GEORGIA POWER COMPANY
OGLETHORPE ELECTRIC MEMBERSHIP CORPORATION
EDWIN I. HATCH NUCLEAR PLANT UNIT 1
AMENDMENT TO FACILITY OPERATING LICENSE

Amendment No. 27
License No. DPR-57

CHANGE NO. 26 TO THE TECHNICAL SPECIFICATIONS

SAFETY EVALUATION BY THE OFFICE OF NUCLEAR REACTOR REGULATION
SUPPORTING AMENDMENT NO. 27 TO FACILITY OPERATING LICENSE NO. DPR-57
(CHANGE NO. 26 TO THE TECHNICAL SPECIFICATIONS)
GEORGIA POWER COMPANY AND OGLETHORPE ELECTRIC MEMBERSHIP CORPORATION
EDWIN I. HATCH NUCLEAR PLANT UNIT 1
DOCKET NO. 50-321

FIGURE 3.11-1 (SHEET 1)
LIMITING VALUE FOR APLHGR
(FUEL TYPE 3)

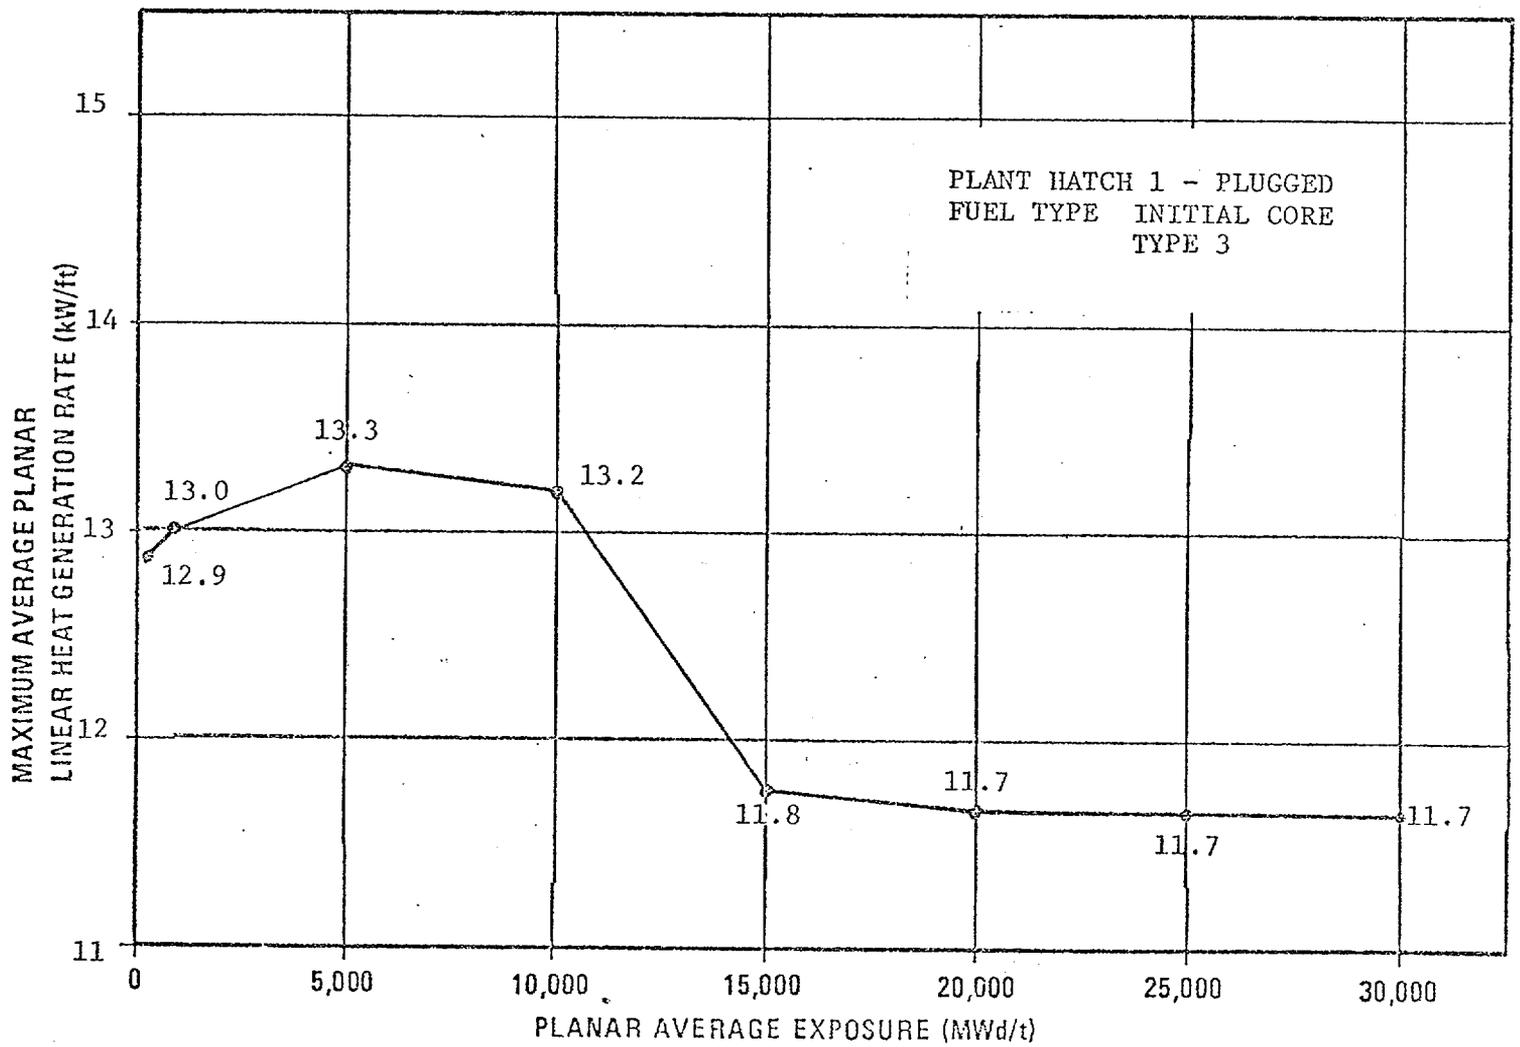
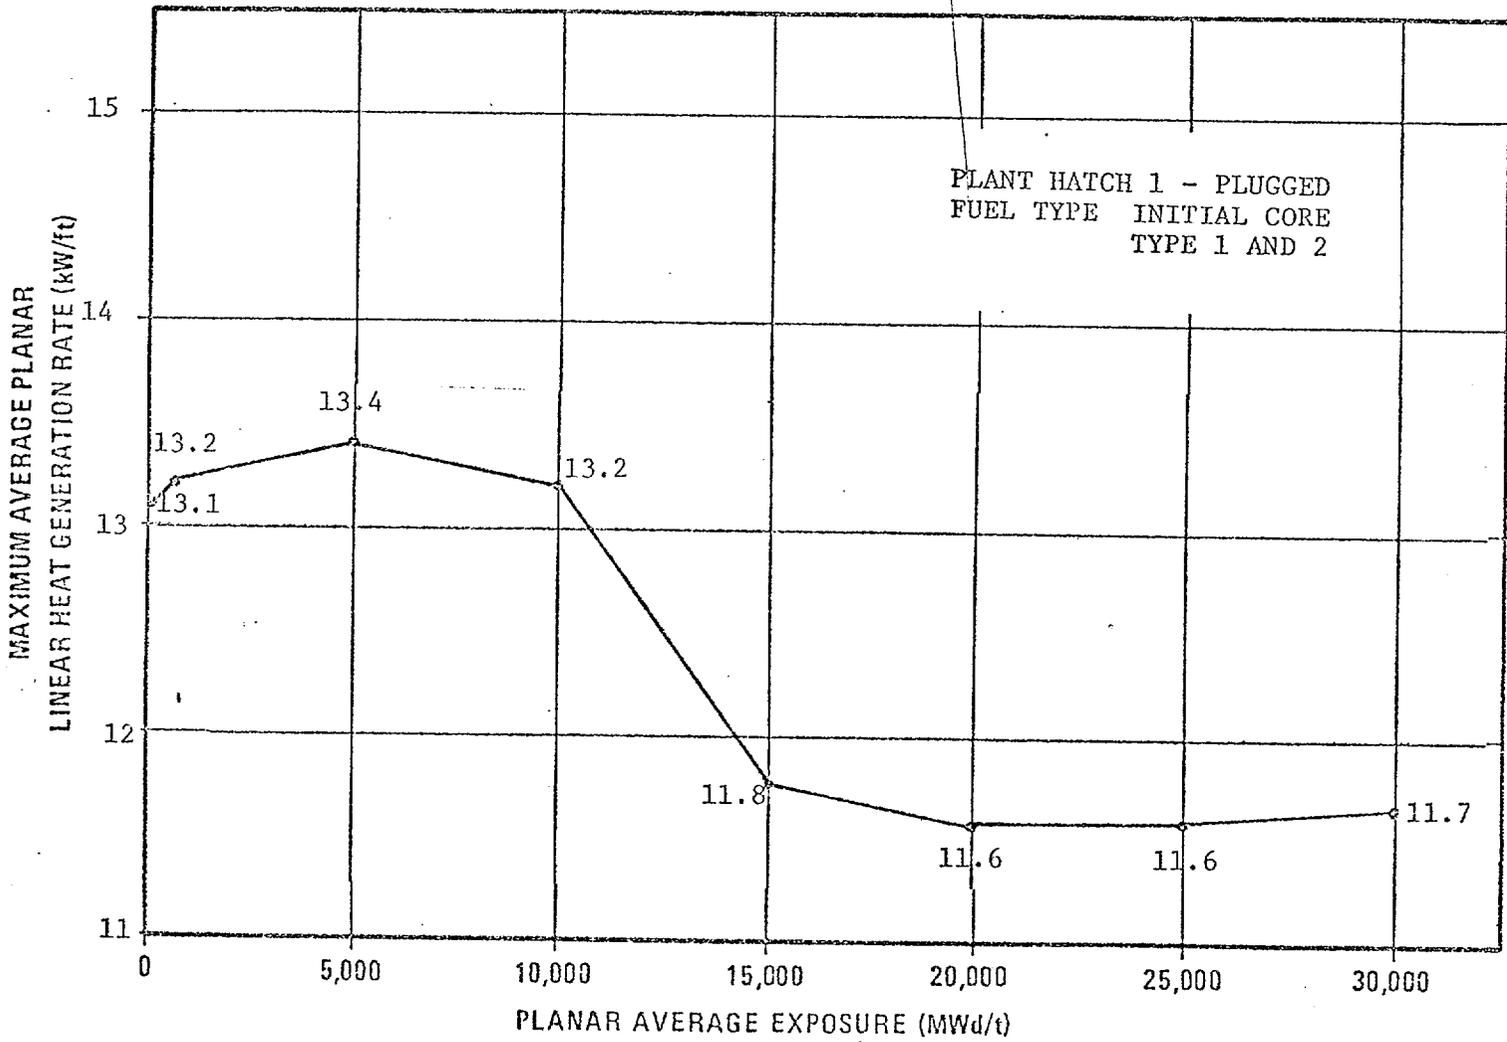
During power operation, the APLHGR for each type of fuel as a function of average planar exposure shall not exceed the limiting value shown in Figure 3.11-1. If at any time during operation it is determined by normal surveillance that the limiting value for APLHGR is being exceeded, action shall be initiated within 15 minutes to restore operation to within the prescribed limits. If the APLHGR is not returned to within the prescribed limits within two (2) hours, the reactor shall be brought to the Cold Shutdown Condition within 36 hours. Surveillance and corresponding action shall continue until reactor operation is within the prescribed limits.

FIGURE 3.11-3

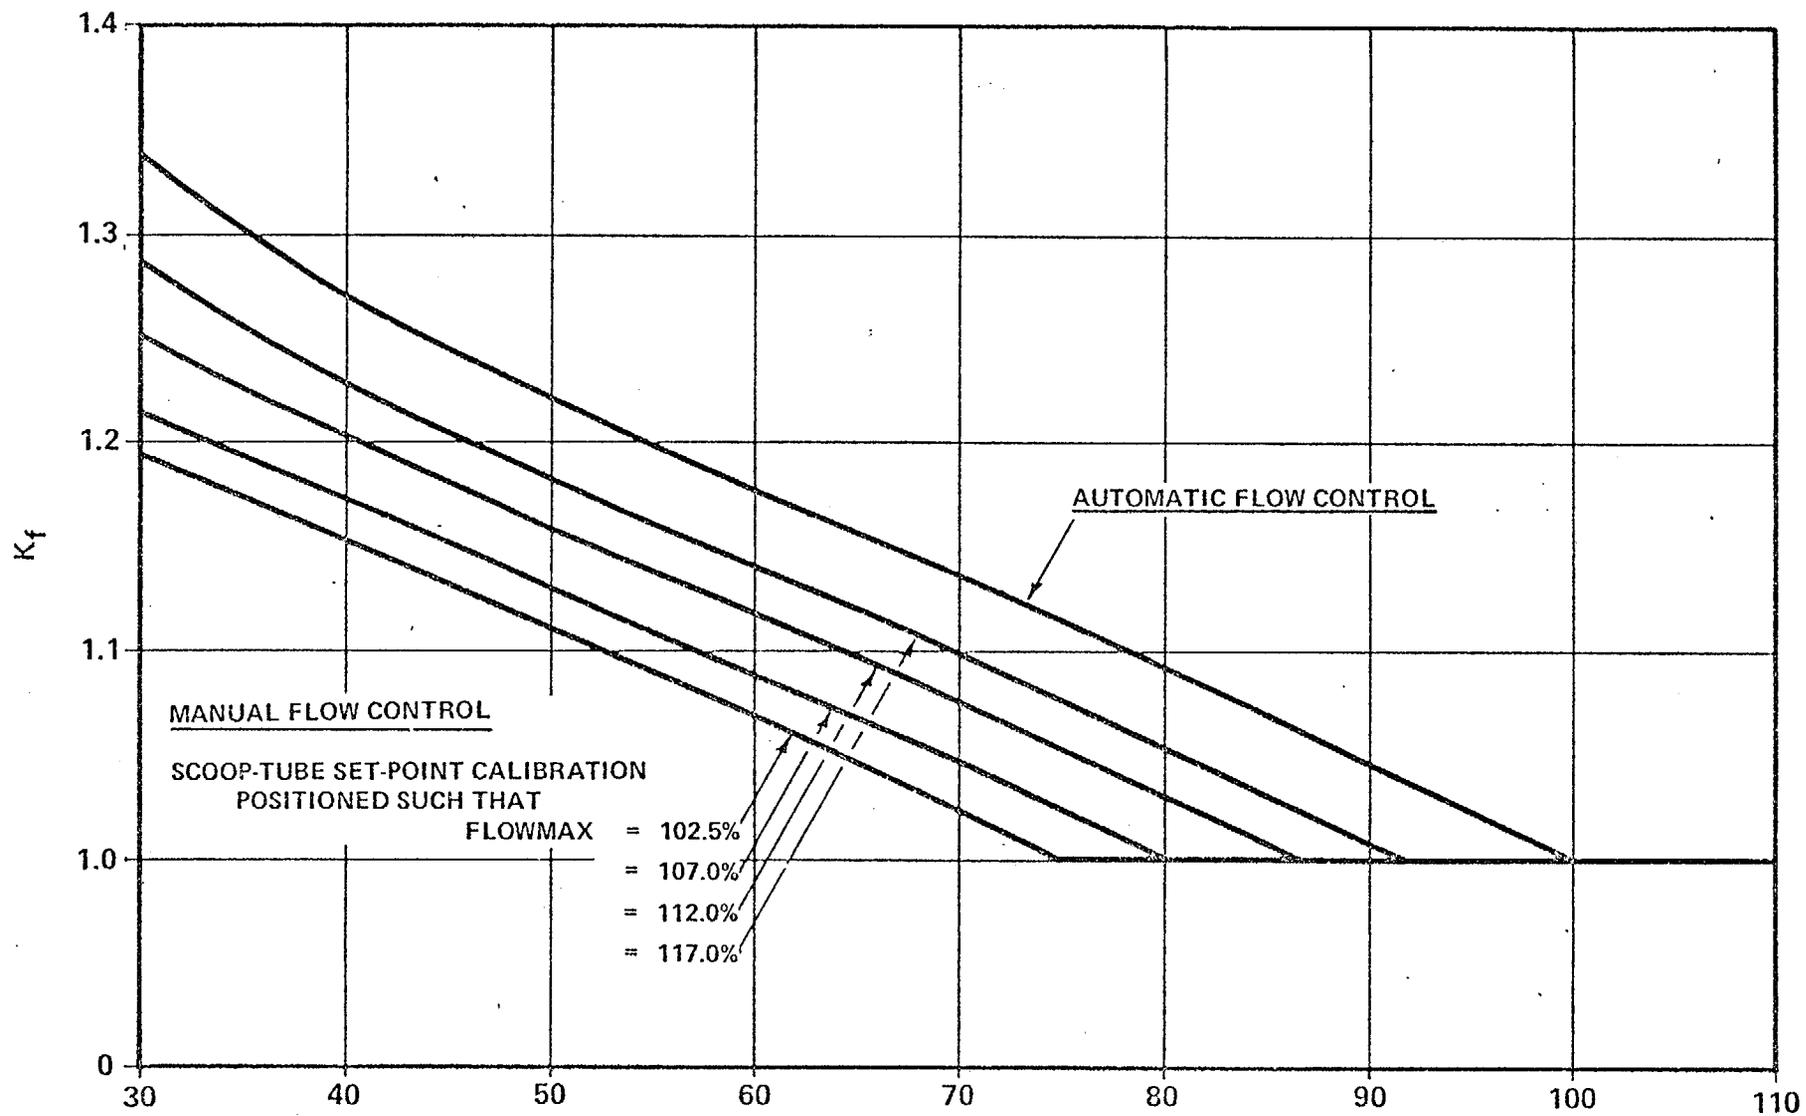
Replace page i, page ix, page 1.0-3, page 1.0-6, page 1.0-7, page 1.1-1, pages 1.1-6 thru 1.1-8, pages 1.1-10 thru 1.1-15, pages 3.2-63 thru 3.2-65, page 3.3-5, page 3.3-10, page 3.3-15, page 3.5-9, page 3.5-18, page 3.6-10, pages 3.11-1 thru 3.11-3, Figure 1.1-1, Figure 3.11-1 (Sheet 1) and Figure 3.11-2 with the attached revised pages. No change has been made on page ii, page 1.0-4, page 1.0-5, page 1.1-2, page 1.1-5, Figure 2.1-1, page 3.2-66, page 3.3-4, page 3.3-6, page 3.3-9, page 3.3-16, and page 3.6-9. Delete page 1.1-9, page 1.1-16 and page 1.1-17. Add page 3.11-4, page 3.11.5, Figure 3.11-1 (Sheet 2) and Figure 3.11-3.
